From: Katherine Sheppard
Sent: 25/01/2022 10:45:17 PM
To: Council Northernbeaches Mailbox
Subject: Submission Re: DA 2021/2478 (No. 44 Kooloora Avenue, Freshwater)
Attachments: Submission Letter.pdf;

**Re: DA 2021/2478 Proposed Alterations and Additions to a Dwelling House
No. 44 Kooloora Avenue, Freshwater**

Figure 3: View line sketch

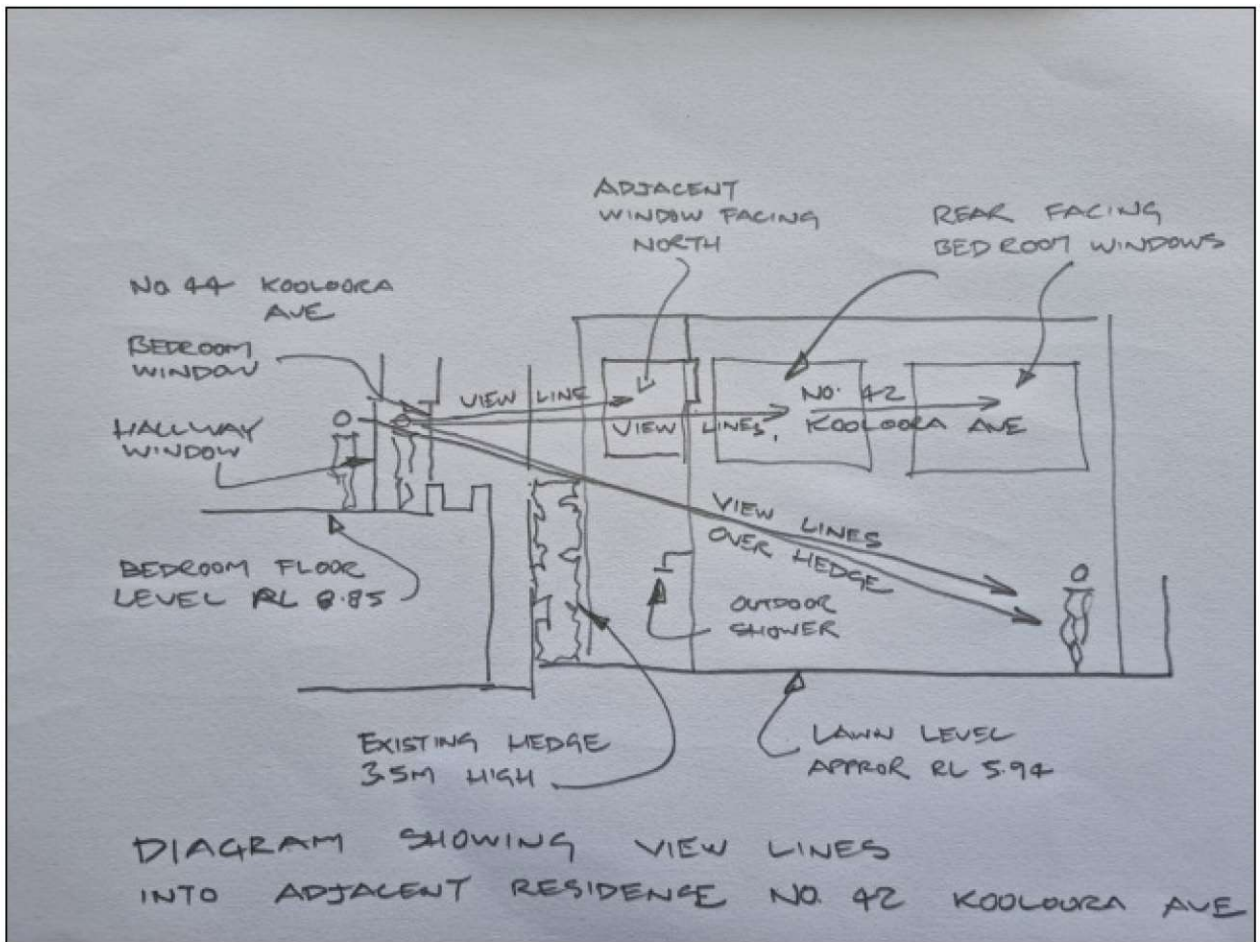
In particular, I am concerned about sightlines from proposed Windows 118, 119 and 120 and respectfully request the following measures:

- provide a fixed vertically bladed screen to Window 120 to direct views to the rear of No. 44.
- convert Window 119 to a high level window to prevent clear sightlines into my son's rear facing bedroom window and to retain privacy at the rear of my property. Refer to the Photos provided at **Figures 1 and 2** and the view line sketch provided at **Figure 3**.
- convert Window 118 in the master bedroom to a low level window that will benefit from the amenity created by the low rise roof garden but that will not have clear sightlines into the rear facing windows in my children's bedrooms or compromise privacy at the rear of my property. Refer to the Photos provided at **Figures 1 and 2** and the view line sketch provided at **Figure 3**.

- convert Window 118 in the master bedroom to a low level window that will benefit from the amenity created by the low rise roof garden but that will not have clear sightlines into the rear facing windows in my children's bedrooms or compromise privacy at the rear of my property. Refer to the Photos provided at **Figures 1 and 2** and the view line sketch provided at **Figure 3**.
